SUBJECT: **Modification Request of Section 404 Regional General Permit No. 31 and Section 401 General Water Quality Certification No. 3886** for the proposed Interstate 85 (I-85) Widening and Interchange Improvements from north of NC 73 (Davidson Highway / Exit 55) to north of SR 2180 (Lane Street/Exit 63), Cabarrus & Rowan Counties, Divisions 9 and 10. Federal Aid Project No. FANHIMF-085-2(61)55, TIP Project No. I-3802A.

In addition to this cover letter, please find the revised permit drawings (Permit Drawing Sheet Nos. 61 – 65 of 128) and revised impact summary sheets (Permit Drawing Sheet Nos. 126 – 128 of 128).

**PERMIT DRAWING  
SHEET 61 OF 128**

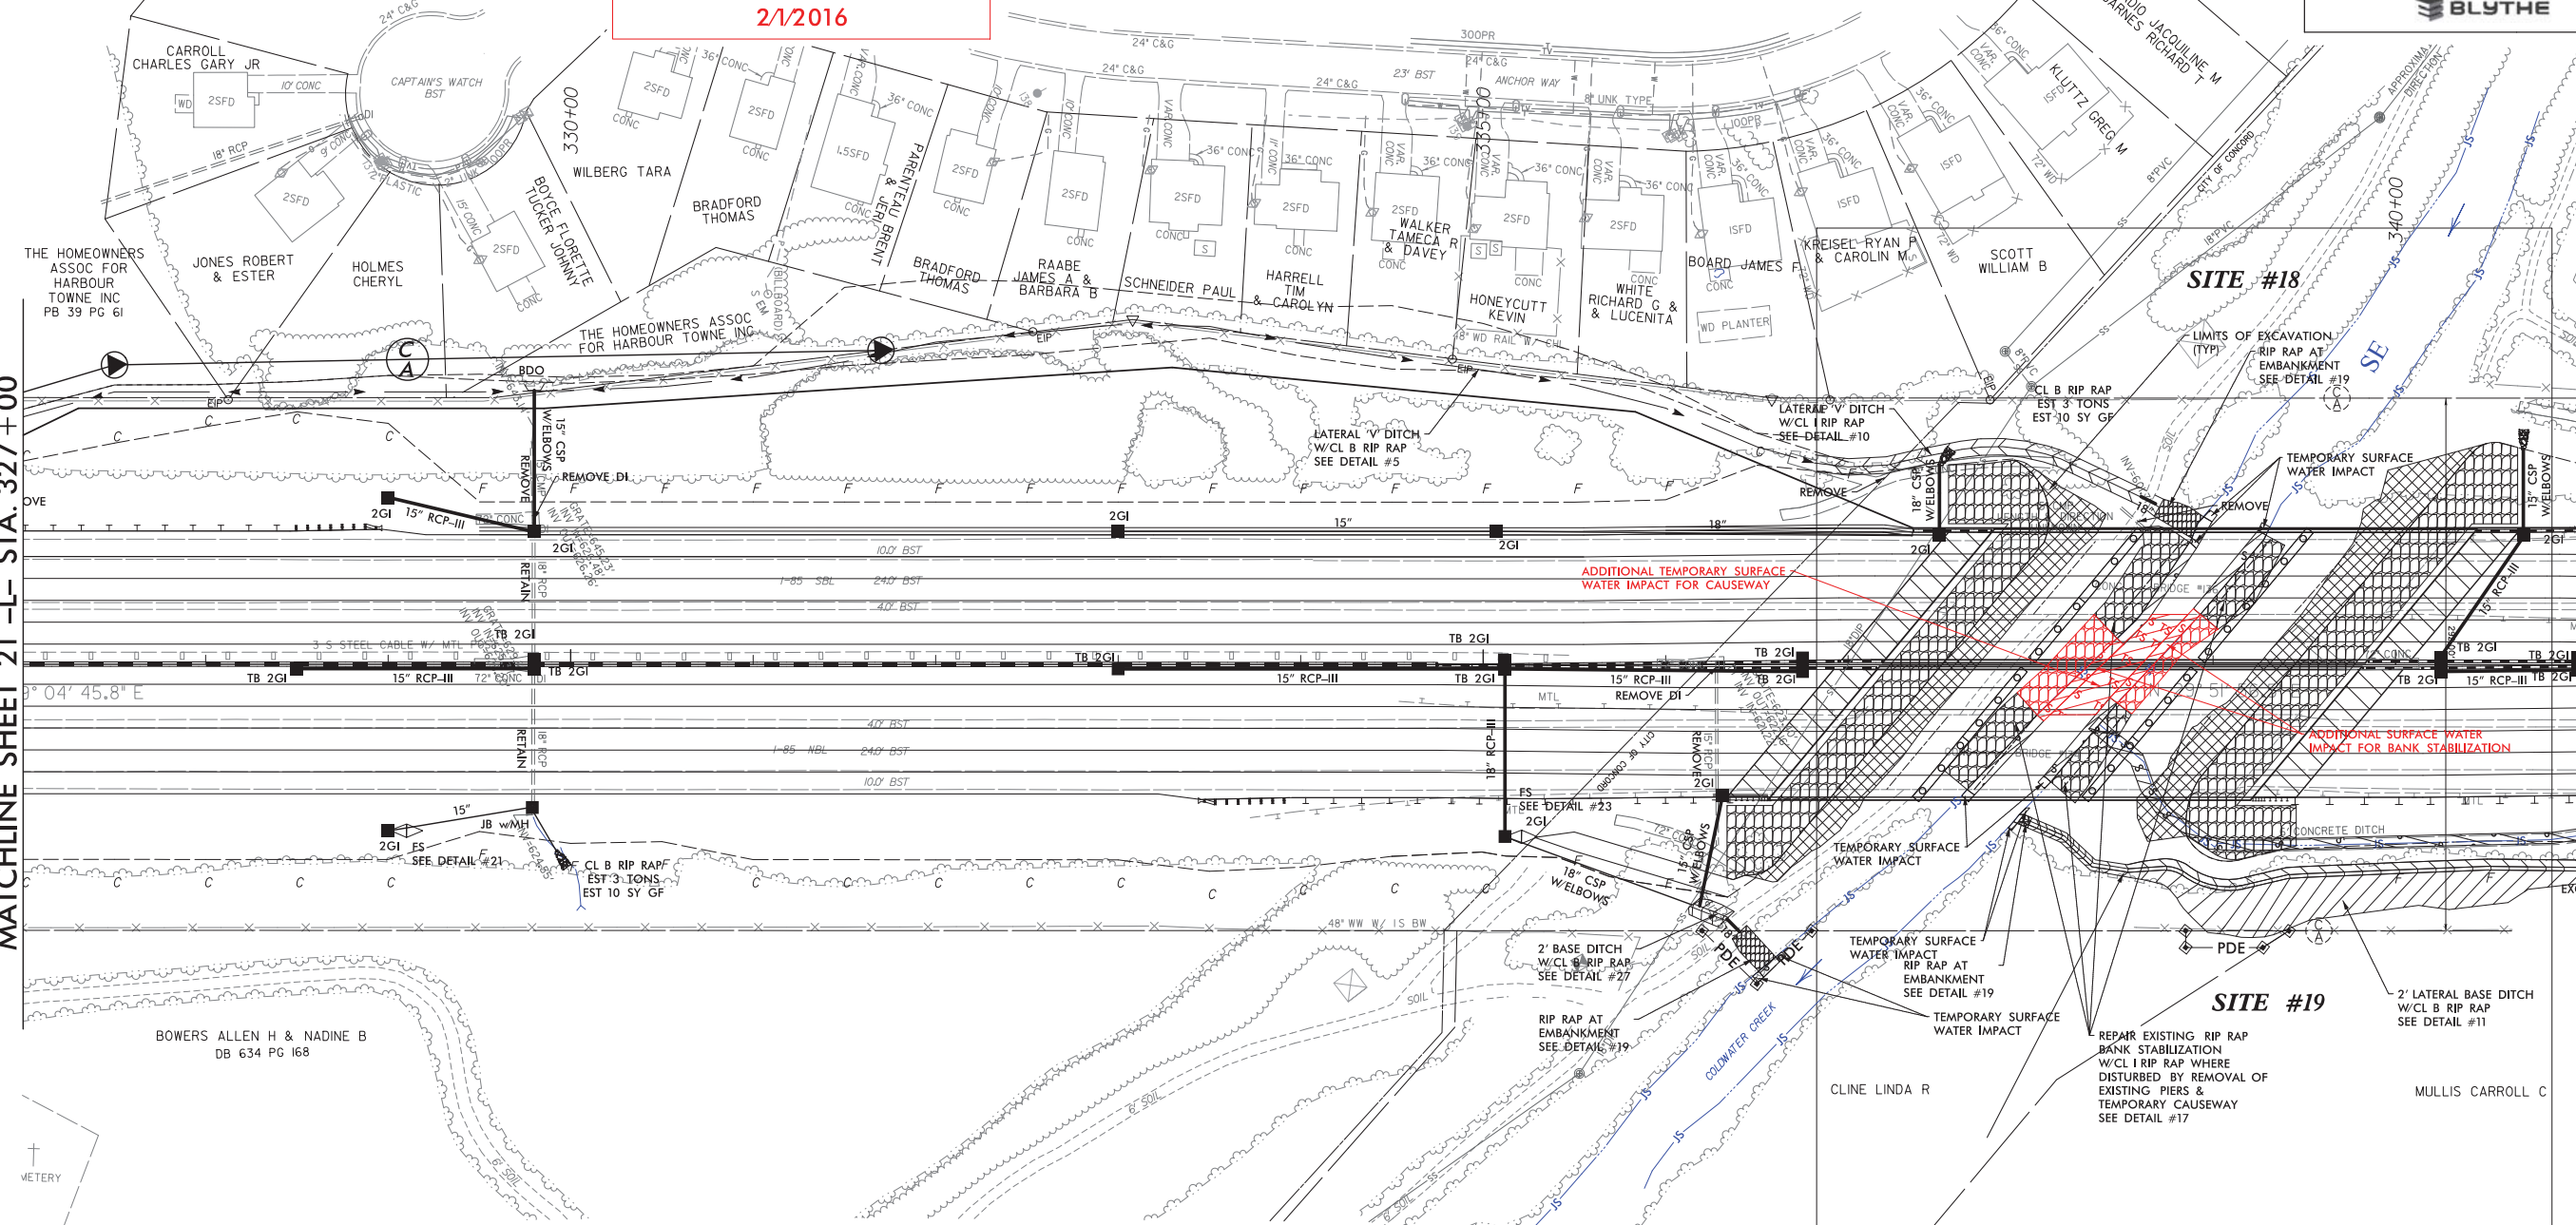
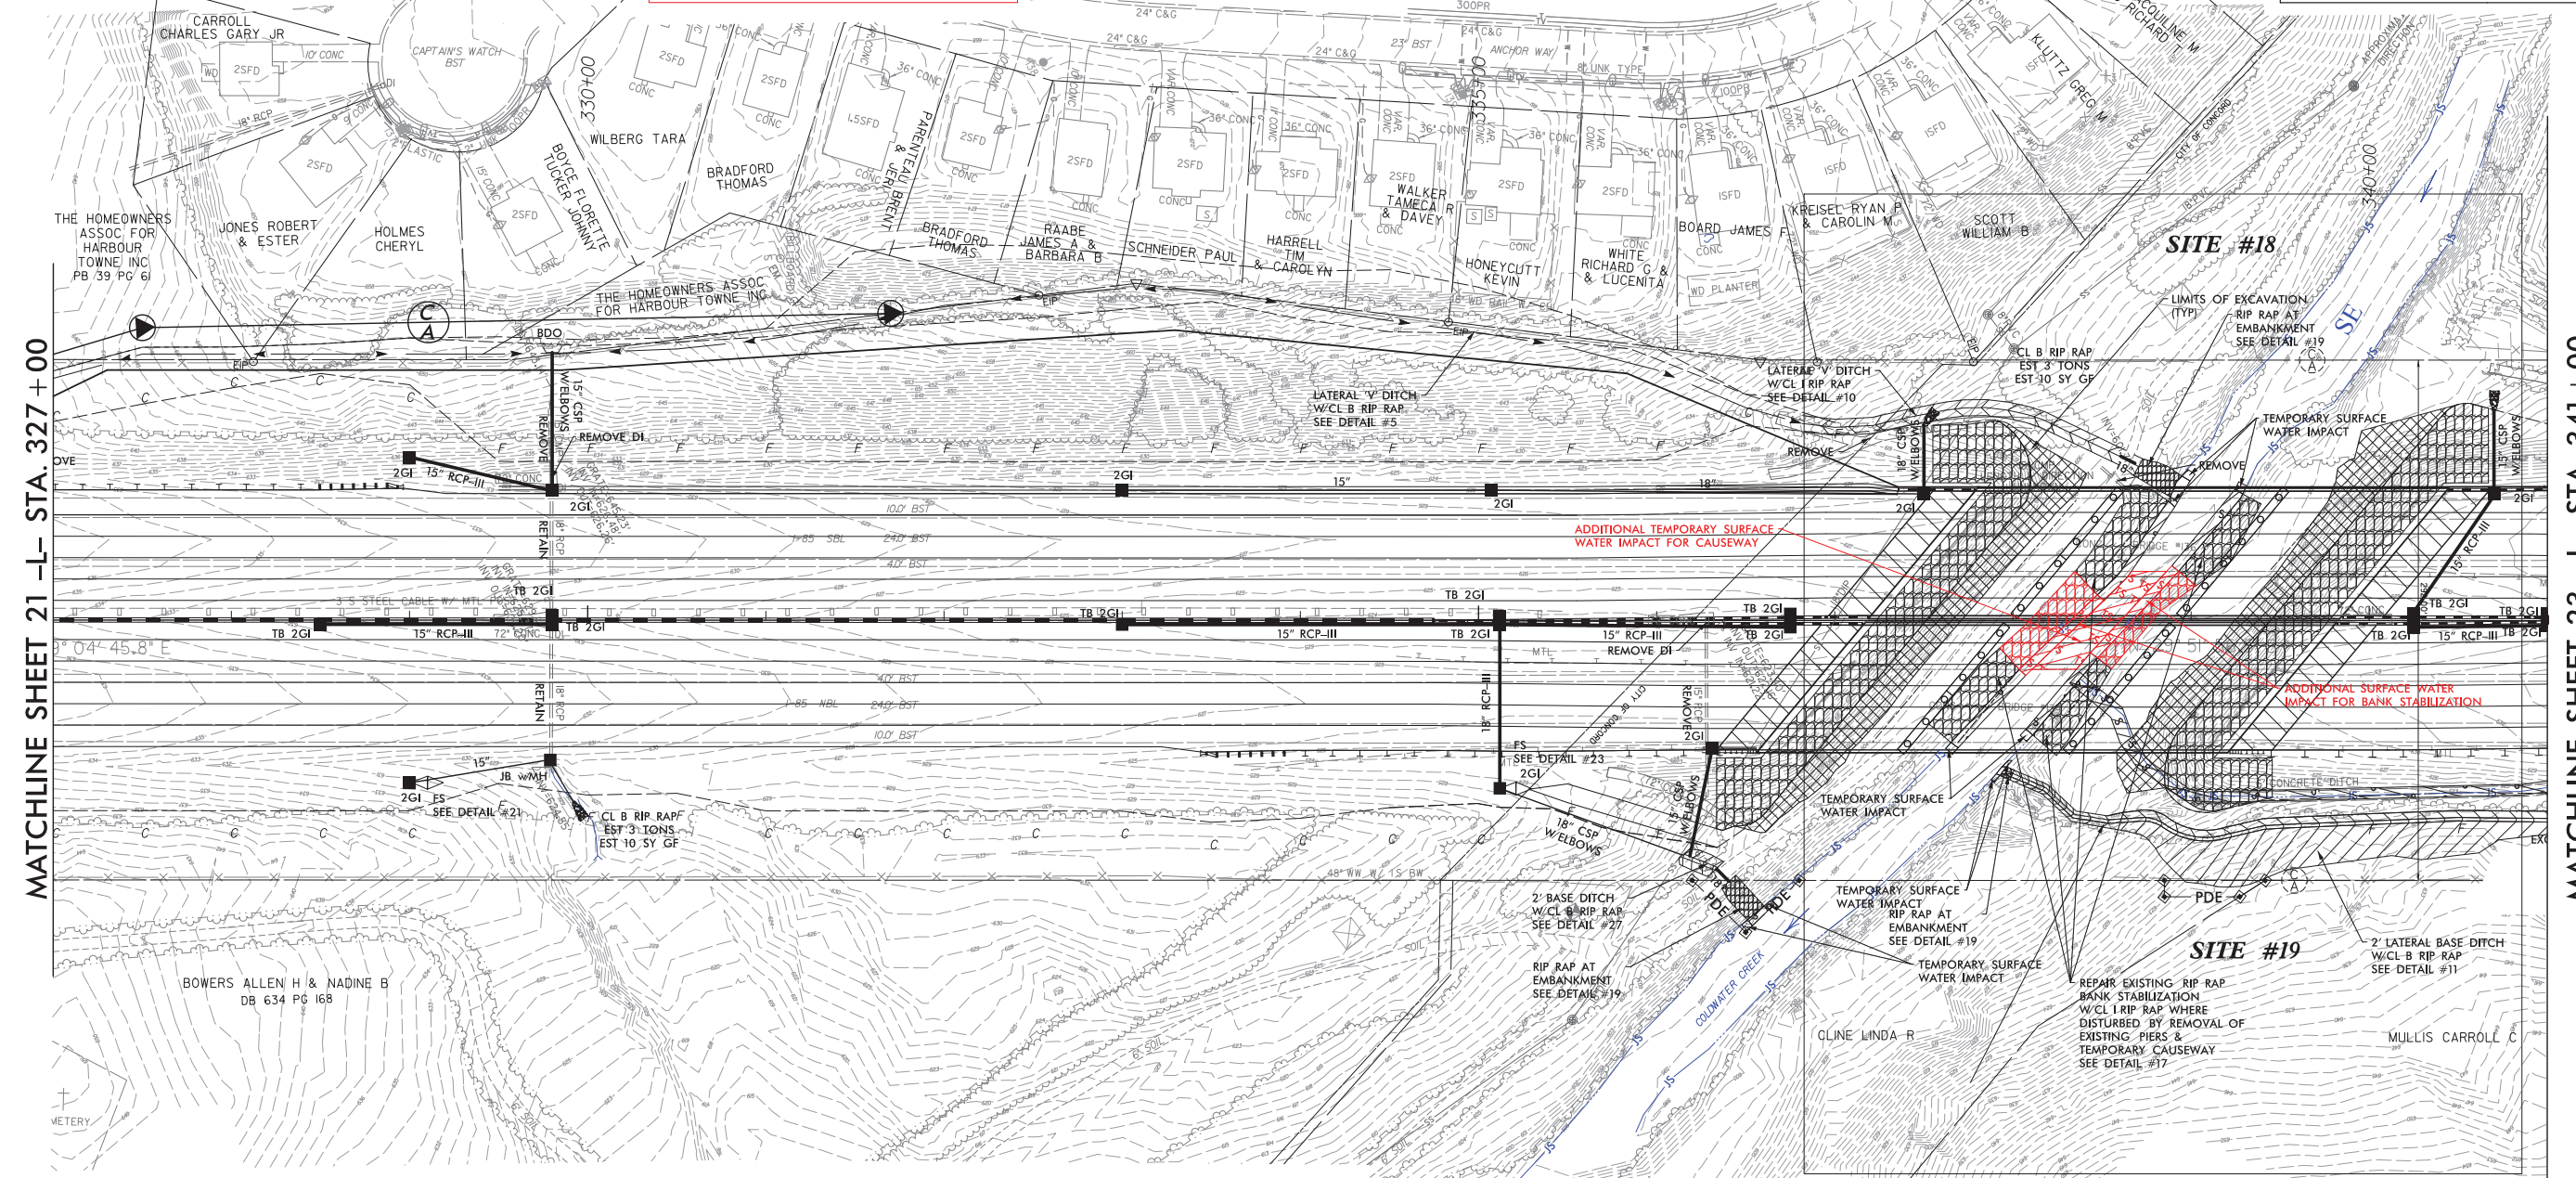
Since the issuance of the above-referenced permit approvals, design changes have occurred which necessitate the need for a temporary stream crossing across Cold Water Creek (Stream SE) and additional bank stabilization. This design change will modify jurisdictional impacts to Waters of the US at Permit Site No. 18.

The temporary causeway at Site 18 is required to enable construction of the proposed I-85 bridges over Cold Water Creek. The temporary stream crossing will utilize a stone causeway with three 72-inch pipe culverts. The causeway will be constructed from Class II riprap and will be topped with a Class B riprap work pad. Geotextile fabric will be installed between the Class II riprap and the stream bed and stream banks. The culverts will allow for 50% or greater flow of the creek through the causeway.

The temporary stream crossing will result in an additional 66 linear feet of temporary surface water impacts as well as 30 linear feet of bank stabilization impacts. The temporary surface water impacts associated with the causeway will occur completely within this site's bank stabilization impact footprint. Previously, Site 18 impacts included 35 linear feet of temporary stream impacts and 185 linear feet of bank stabilization impacts. The proposed overall total for Site 18, including the previously-permitted impacts as well as the currently proposed impacts, will be 101 linear feet of temporary and 215 linear feet of bank stabilization impacts. No other changes to permitted wetland and stream impacts are proposed for the project.

**PERMIT DRAWING SHEET 63 OF 128**

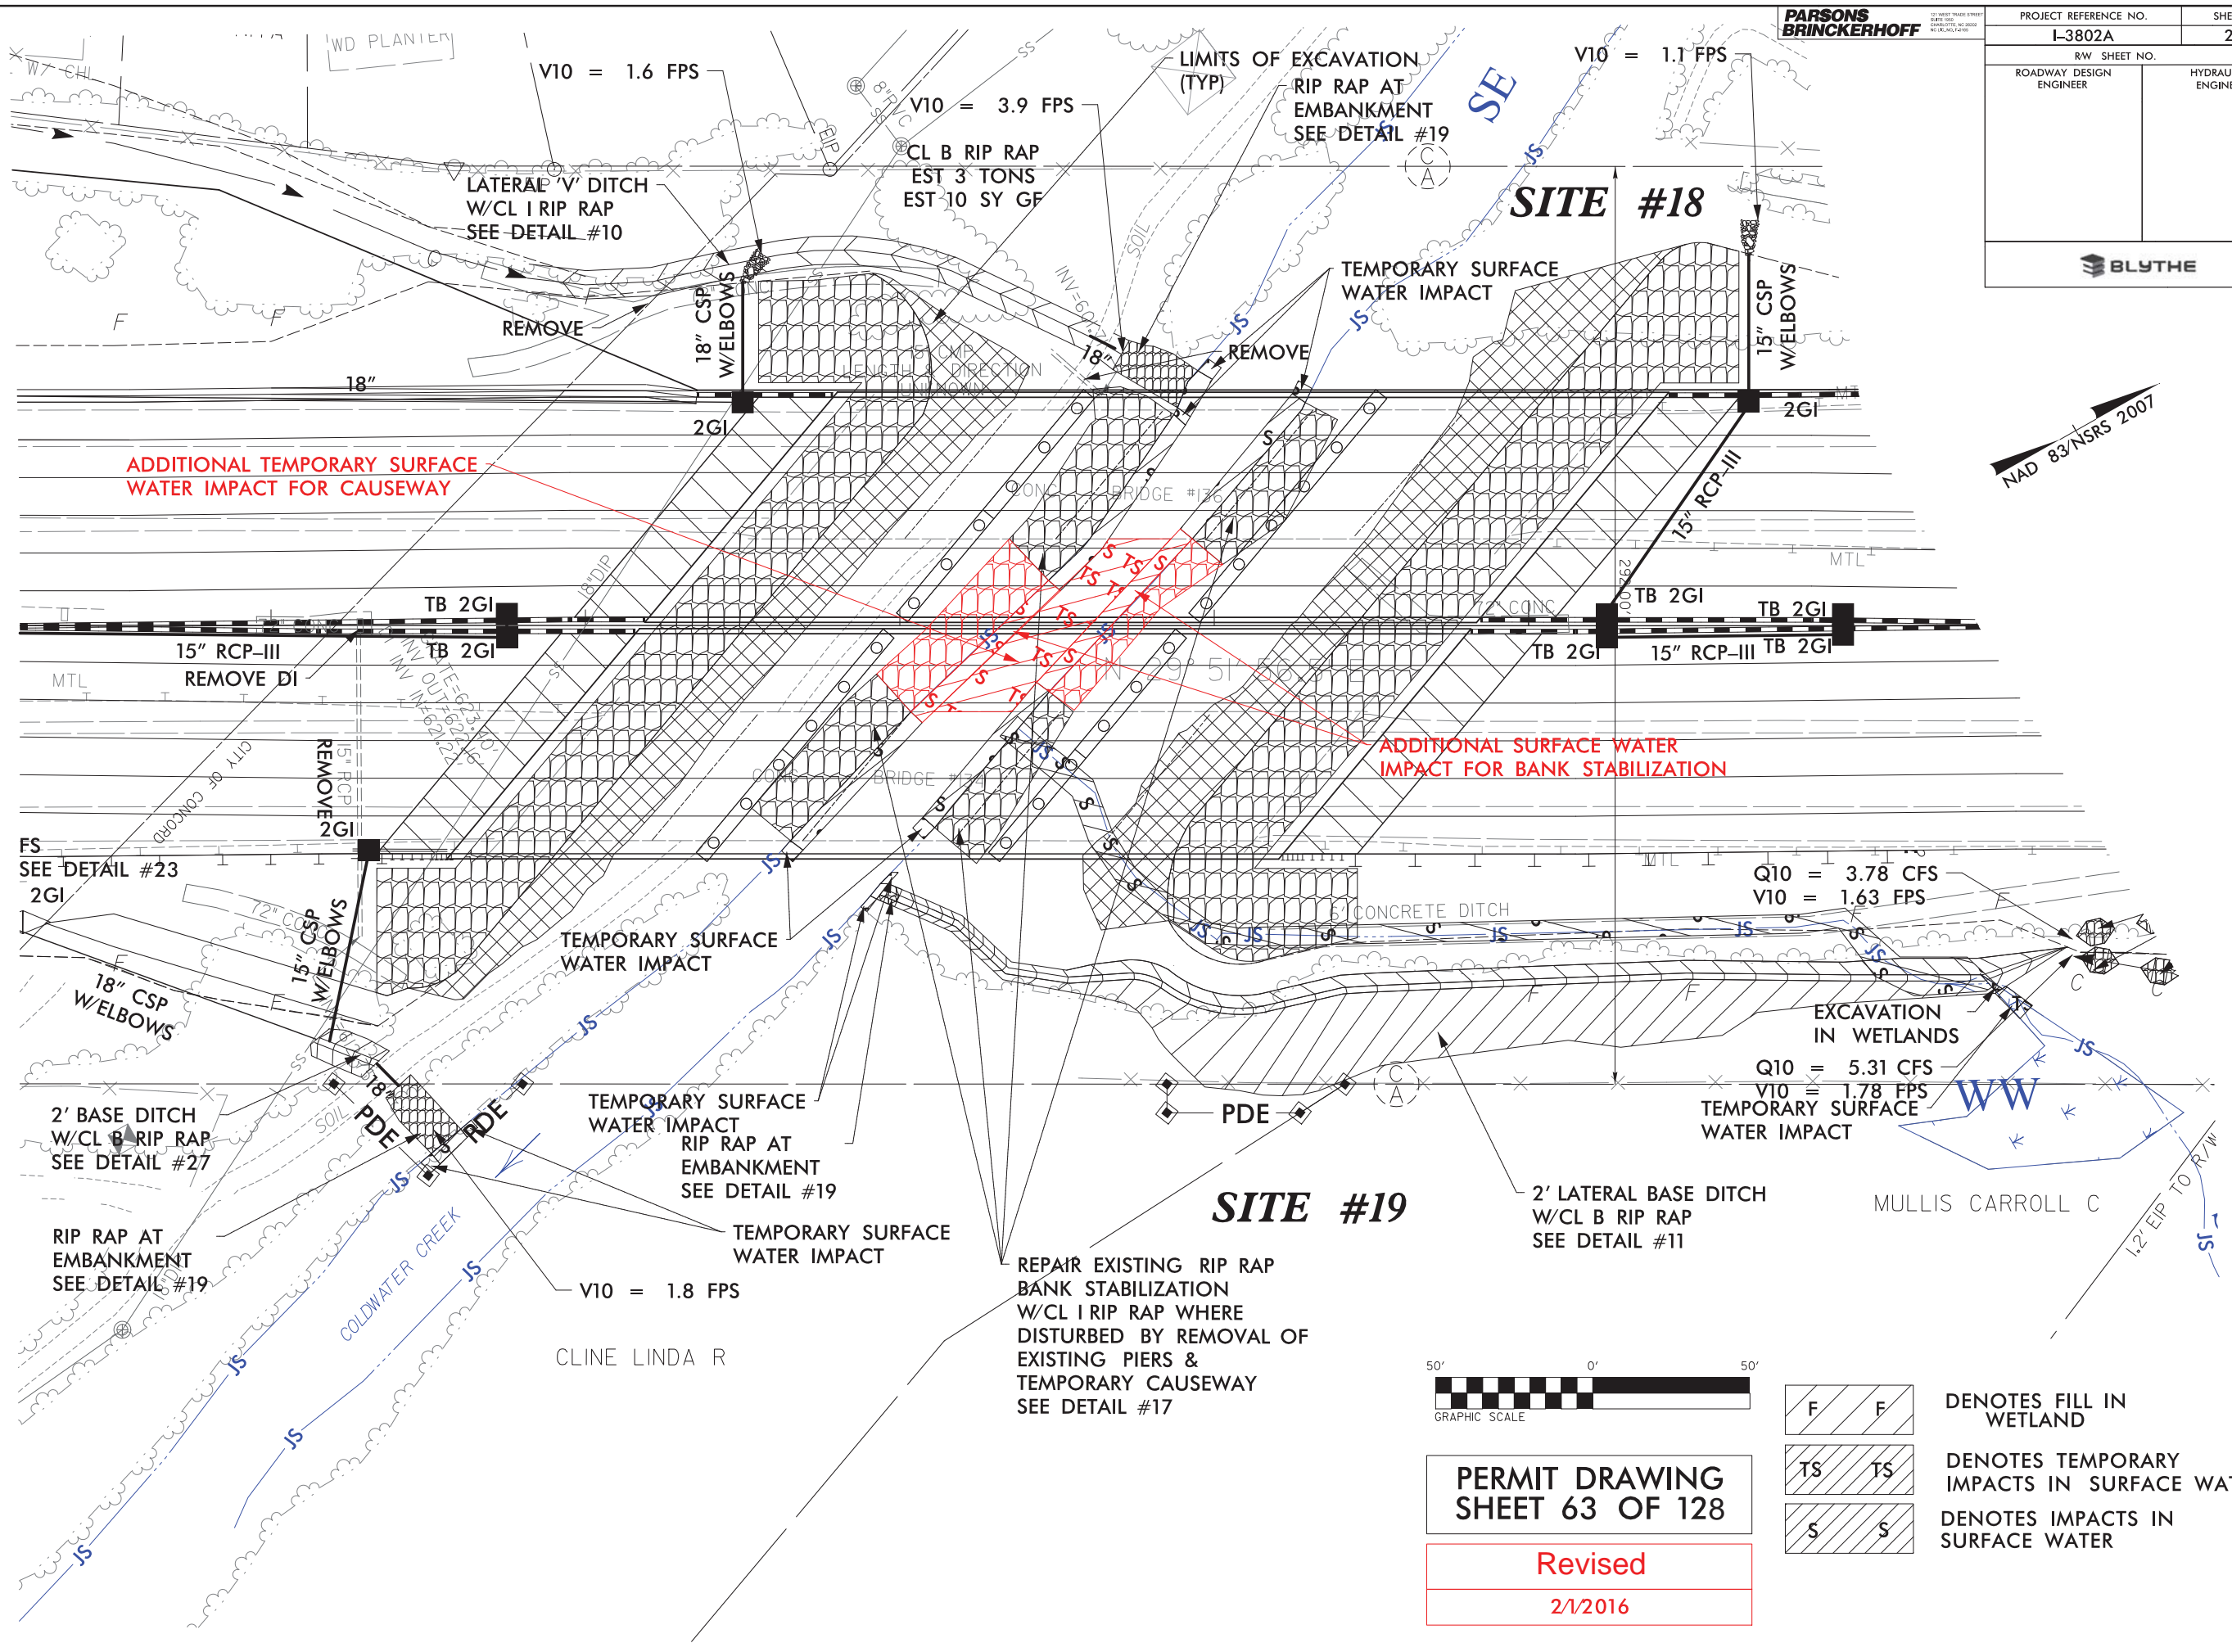
Bank stabilization consisting of Class II riprap will be installed where the stream banks have been impacted by installation of the causeway.
